To: Kristopher Byrd, Well Construction and Compliance Section Manager
From: Travis Kelly, Well Construction Program Coordinator
Subject: Review of Water Right Application LL-1836
Date: July 7, 2020

Application # G- LL1836

TO: Water Rights Section Date 7/2/2020
 FROM: Groundwater Section Jen Woody
 Reviewer's Name
 SUBJECT: Application LL- 1836 Supersedes review of n/a
 Date of Review(s)

A. GENERAL INFORMATION: Applicant's Name: RLK Smith Orchards County: Washington

Figure 2. Well Location Map

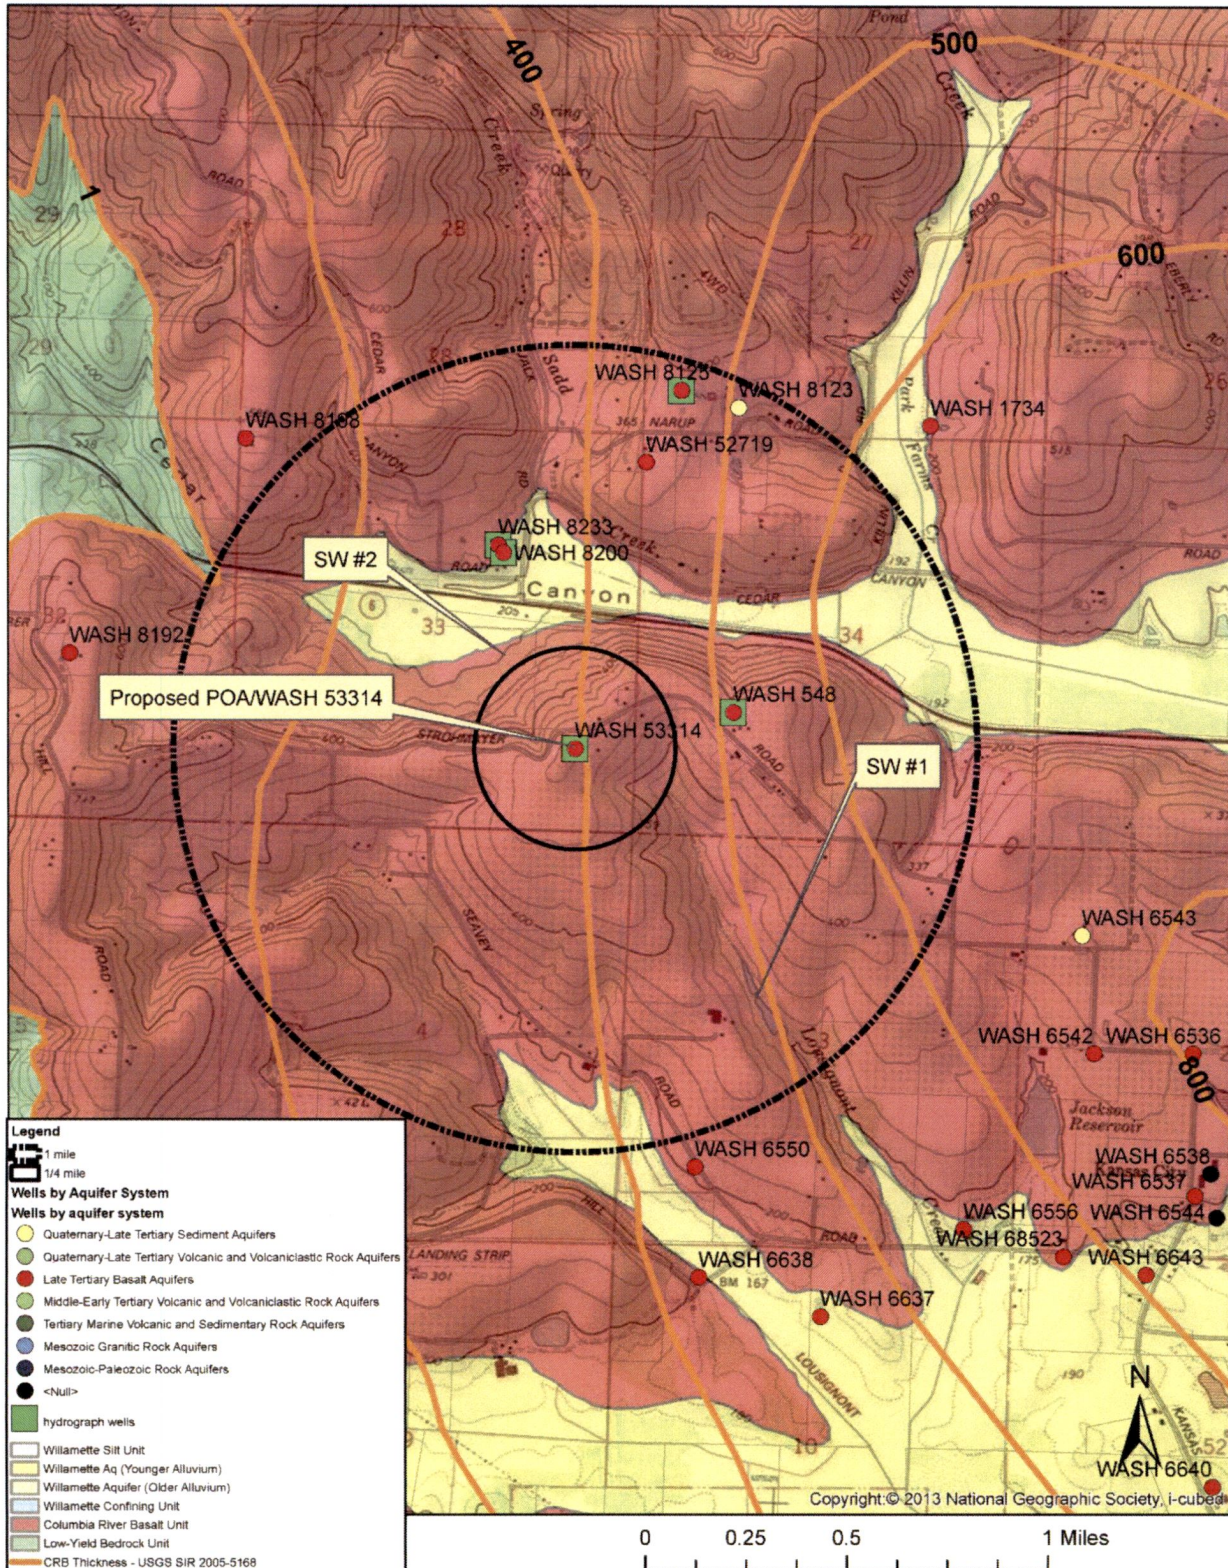
- A4. **Comments:** The well location was provided as a dot on the application map with no coordinates. For the purposes of this review, the POA location was estimated using the application map, taxlot and aerial photographic information at latitude/longitude (45.61003016, -123.17919290).
-
- A5. **Provisions of the** Willamette Basin rules relative to the development, classification and/or management of groundwater hydraulically connected to surface water **are,** or **are not,** activated by this application. (Not all basin rules contain such provisions.)
 Comments: The well produces from a confined aquifer, therefore the pertinent rules (OAR 690-502-240) to not apply.
-
- A6. **Well(s) #** _____, _____, _____, _____, _____, tap(s) an aquifer limited by an administrative restriction.
 Name of administrative area: n/a
 Comments: _____
